**NW Natural Pre-Remedial Design Data Gaps Sampling
US Moorings Project Area Second Phase PDI – Spring 2023
Field Change Request Form**

Field Activity: Seepage Meter Deployment **Request Number:** 2

Field Change Request (FCR) Title: Relocation of Subsurface Sediment Sampling Locations

Figure 1
 Revised Proposed Second Phase PDI Dredge Material Barge Dewatering Treatment and Stabilization Evaluation Sampling Locations

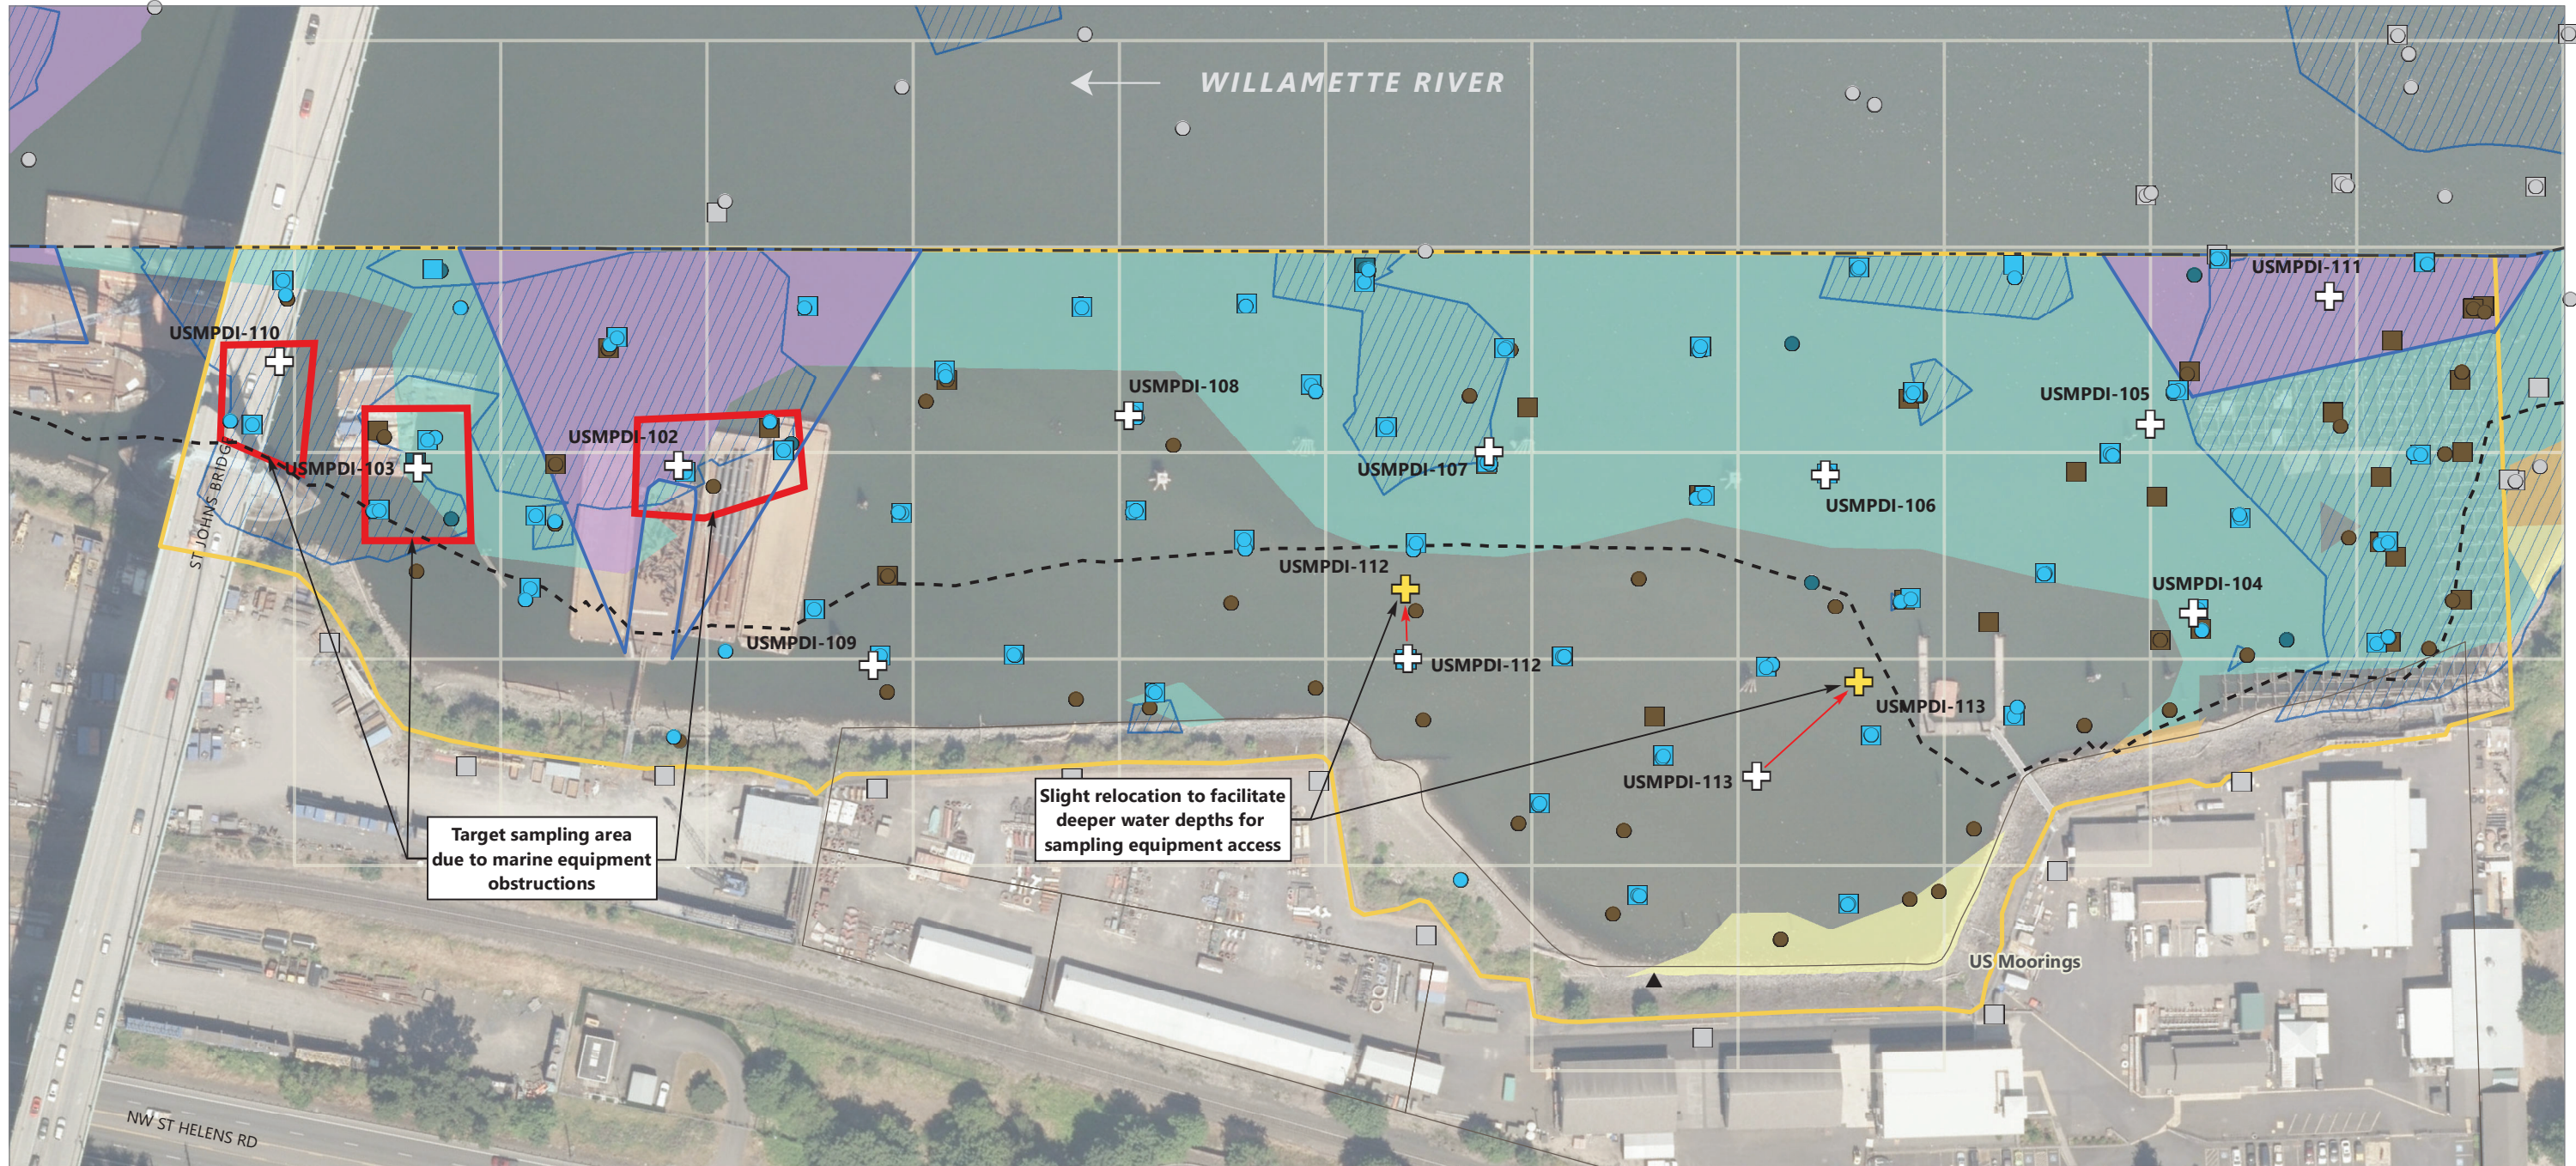
Recommended Change
<p>NW Natural proposes that all subsurface sediment sampling outside of the navigation channel be collected using the 15-foot coring assembly rather than the 20-foot assembly identified in the Work Plan. As noted above, this assembly can achieve the deepest required sampling depth of 7 feet below mudline. The 20-foot assembly was only identified for these locations because this deeper assembly is necessary for the collection of the depth of contamination cores within the navigation channel. NW Natural further proposes that locations USMPDI-112 and USMPDI-113 be slightly repositioned as shown in the attached Figures 1 and 2 for both the dredge material dewatering treatment and stabilization evaluation and the waste disposal characterization evaluation, respectively. The revised sampling coordinates are identified in the attached revised Tables G3-2 and G3-3 from Appendix G of the Work Plan.</p> <p>NW Natural also proposes that subsurface sediment sampling at locations USMPDI-102, USMPDI-103, and USMPDI-110 be performed within the polygons shown in the attached Figures 1 and 2 due to the identified marine equipment obstructions. Anchor QEA developed these polygons based on review of the existing</p>

subsurface sediment data in the vicinity of these locations and confirmed the expanded sampling areas will achieve the data quality objectives identified in the Work Plan. NW Natural will further coordinate with the U.S. Environmental Protection Agency (EPA) if Anchor QEA is unable to obtain access to sample within any of these areas and therefore is unable to complete the EPA-approved sampling.
